RE: Sigma Chi Apartments 1815 Sigma Chi Road NE Grading and Drainage Plan Engineer's Stamp Date: 9/19/2024 Hydrology File: J15D102

DRAINAGE AND TRANSPORTATION INFORMATION SHEET (DTIS)

GRADING AND DRAINAGE PLAN

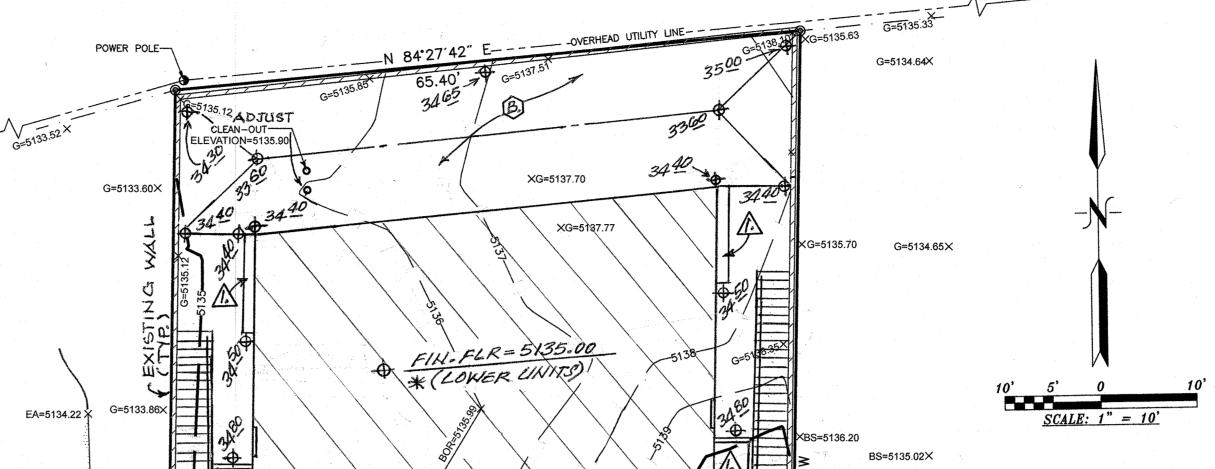
Based upon the information provided in your submittal received 10/08/2024, the Grading & Drainage Plan is approved for Building Permit and Grading Permit. Since this site is relatively flat, a pad certification is not needed for this project. Please attach a copy of this approved plan in the construction sets for Building Permit processing along with a copy of this letter.

1. Engineer's Certification, per the DPM Part 6-14 (F): *Engineer's Certification Checklist For Non-Subdivision* is required.
